ALABAMA ROLL PRODUCTS

APPLICATION NUMBER 11 DATE May 1, 2008

ALABAMA ROLL PRODUCTS SUBDIVISION

DETAIL SITE PLAN

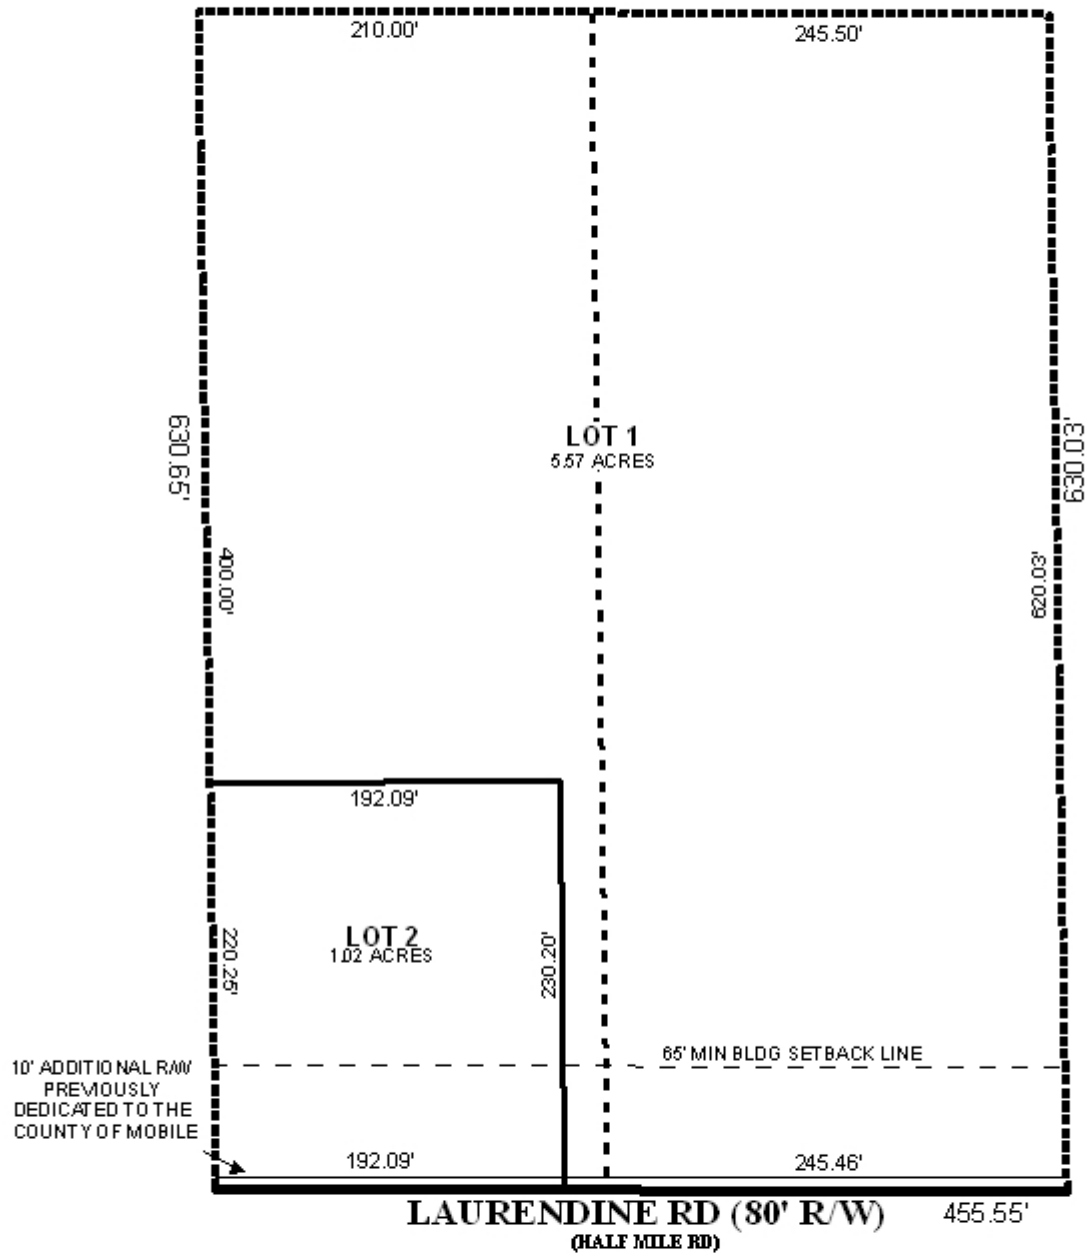
As proposed, Lots 1 and 2 have approximately 245 and 192' of frontage along Laurendine Road respectively. As a means of access management, a note should be placed on the final plat stating that Lot 1 is limited to two curb cuts and Lot 2 is limited to one curb cut to Laurendine Road, with the size, location, and design to be approved by County Engineering and conform to AASHTO standards.

The site is located in the county. Therefore, a note should be placed on the final plat stating that any lots developed commercially and adjoin residentially developed property must provide a buffer, in compliance with Section V.A.7. of the Subdivision Regulations.

While the site is located in the county, compliance with the City of Mobile storm water and flood control ordinances will be required. A letter from a licensed engineer certifying compliance with the City's storm water and flood control ordinances should be submitted to the Mobile County Engineering Department and the Planning Section of Mobile Urban Development prior to the issuance of any permits.

- 1) placement of a note stating that Lot 1 is limited to two curb cuts and Lot 2 is limited to one curb cut to Laurendine Road, with the size, location, and design to be approved by County Engineering and conform to AASHTO standards;

- 2) placement of a note on the plat / site plan stating that the site must be developed in compliance with all local, state and Federal regulations regarding endangered, threatened or otherwise protected species;

- 3) placement of a note on the final plat stating that any lots developed commercially and adjoin residentially developed property shall provide a buffer in compliance with Section V.A.7. of the Subdivision Regulations; and

- 4) submission of a letter from a licensed engineer certifying compliance with the City of Mobile's storm water and flood control ordinances to the Mobile County Engineering department and the Planning Section of Mobile Urban Development prior to issuance of any permits.
